CITY OF ALBUQUERQUE

Planning Department
Alan Varela, Director

Re: Sichler Farms Remodel
820 San Mateo Blvd. NE
Albuquerque, NM 87108
Traffic Circulation Layout
Engineer's Stamp 03-05-26 (K17D129)

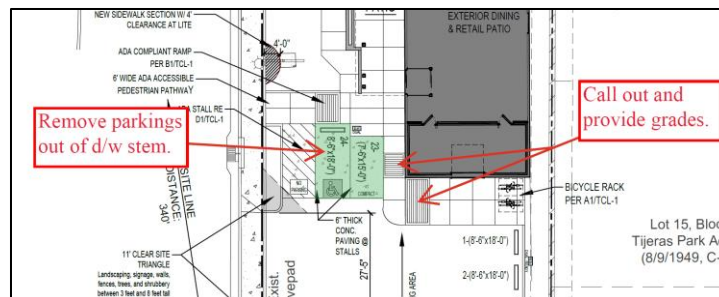
8. Call out ramps on the above site plan snippet, and provide grades.
9. Provide building entrance in relation to ADA pathway.
